SERVICE BULLETIN

INSPECTION OR REPLACEMENT OF THE ROCKER ARMS AND VALVE PUSH-RODS FOR ROTAX® ENGINE TYPE 912 AND 914 (SERIES)

SB-912-035 R1

SB-914-021 R1

fig. 4

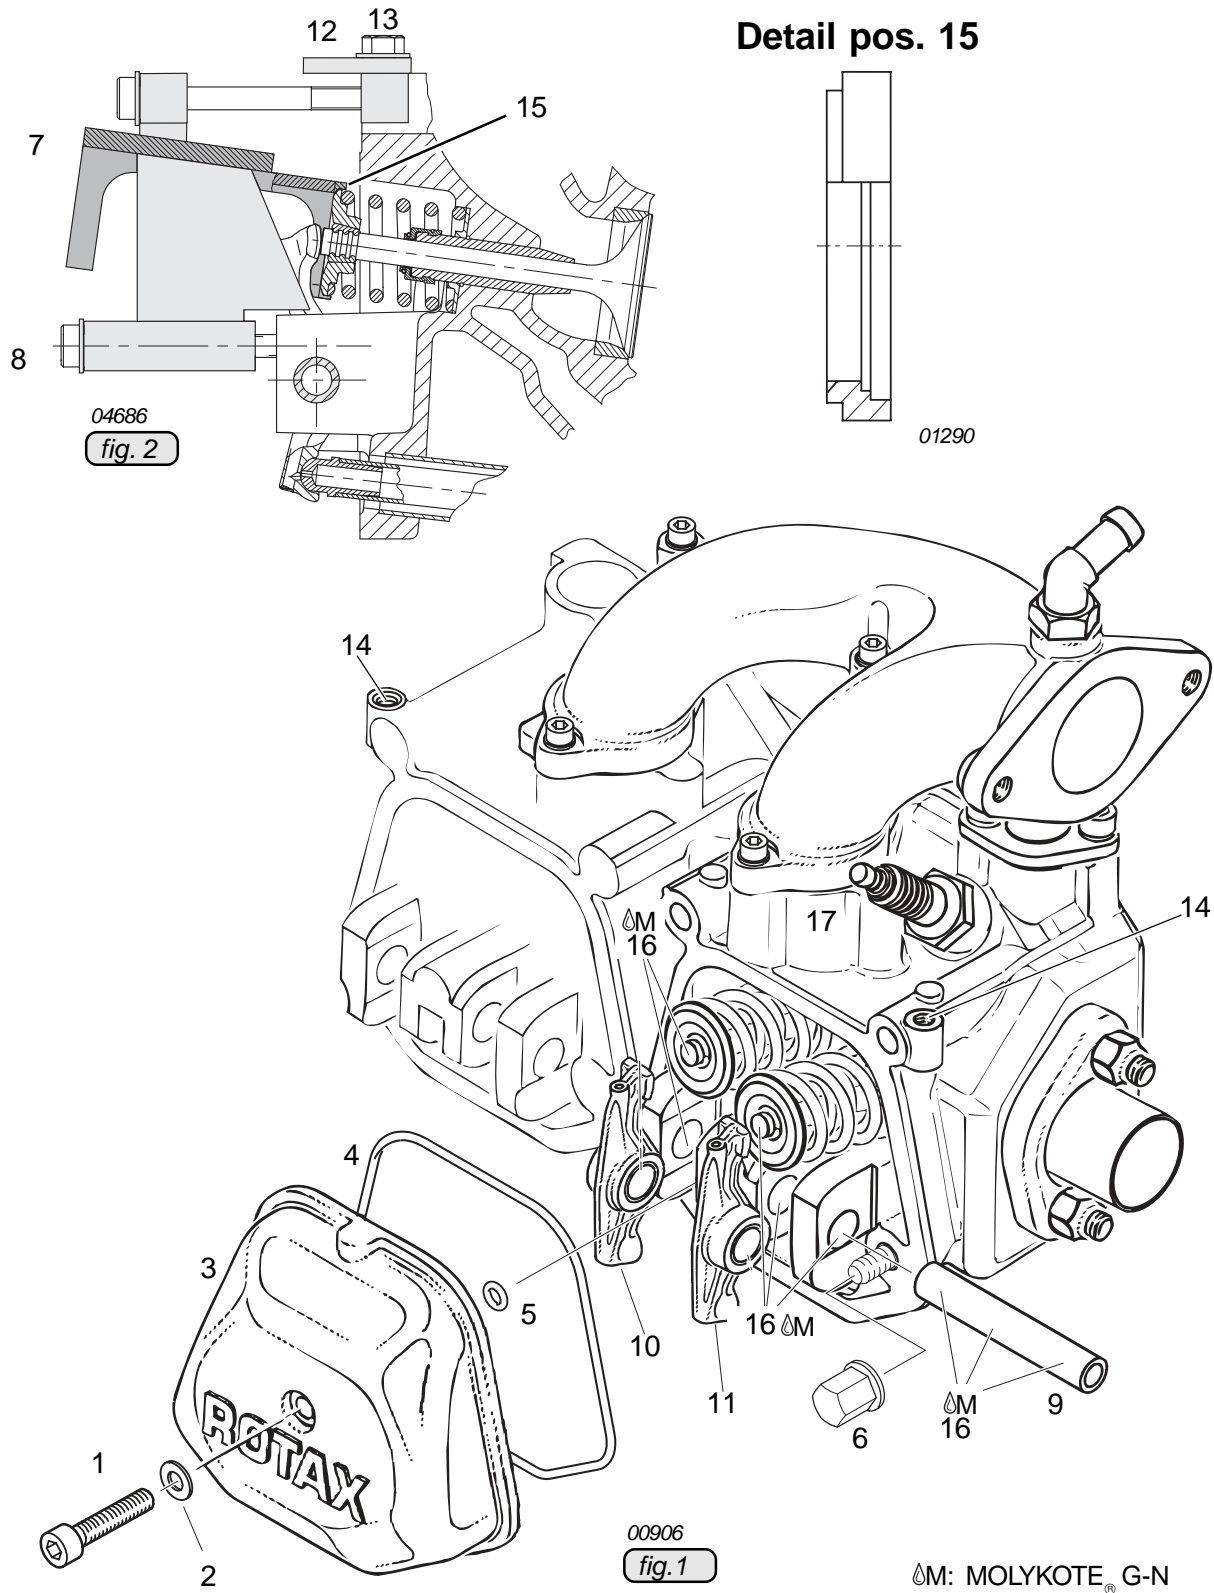
◆ NOTE: Detailed visual inspection particularly in the rocker arm ball joint (female) area.
See fig. 4.

- Inspect rocker arm ball joint (female) (18). Traces of wear on the rocker arms are noticeable by geometric changes of the spherical form and smoothened areas in the ball joint shine brightly. Should the engine not have been running for more than one month, then the shining part may become dull again. The diameter of the smoothened running surface, measured by a sliding caliper (or equivalent) along the rocker arm axis, shall not exceed a value of $d_1 = 6,0 \text{ mm}$ (0.24 in.). Inspect lubricating bore (19) $d_2 = 2,0 \text{ mm}$ (0.079 in.) for roundness. The roundness tolerance must lie within 0,2 mm (0.0079 in.). Any tendency towards an oblong hole is not permissible.

- Should one of these criteria be encountered, replace the appropriate rocker arm **and** its associated push-rod.

fig. 3

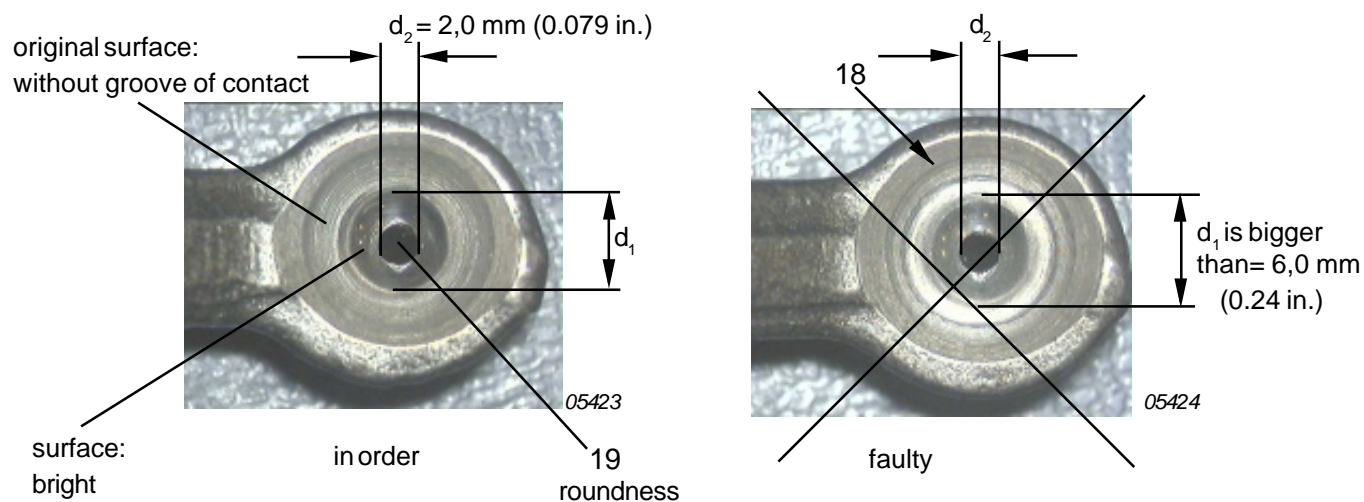
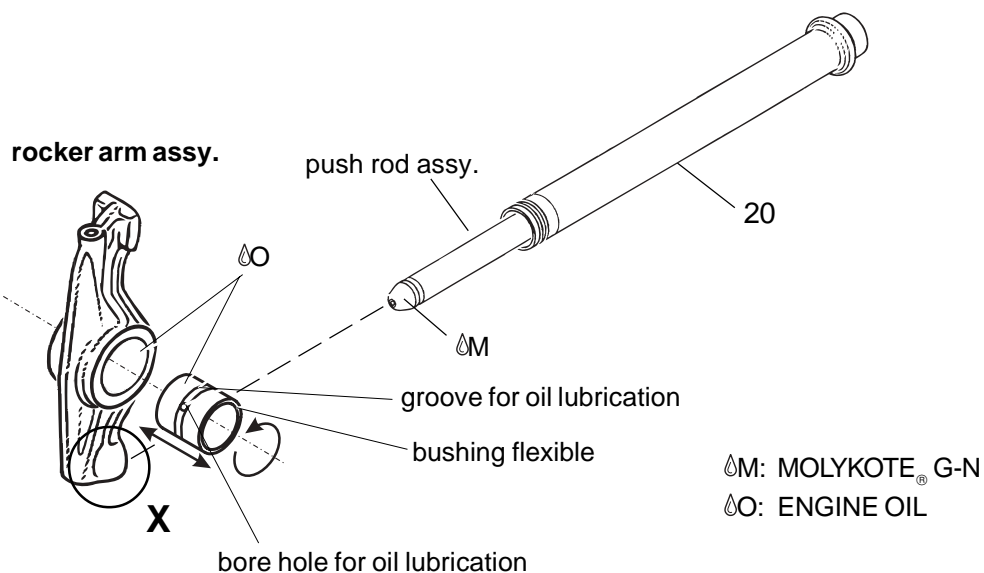
- Visually inspect all rocker arms and push-rods for damage or wear and tear. You may reuse the parts, provided that the accomplishment of the instructions of rocker arms and push-rod did not substantiate damages or traces of wear.

- Apply MOLYKOTE® G-N M(16) on both push-rod ball joints and contact areas of rocker arm and slide push-rod into the oil return tube (20).
- Install rocker arm bushing into inlet rocker arm (10) and outlet rocker arm (11). Put oil on the rocker arm bushing.

- Place inlet rocker arm (10) and outlet rocker arm (11) in cylinder head, apply MOLYKOTE® G-N (16) on rocker arm shaft (9) and insert it into its bearing support.
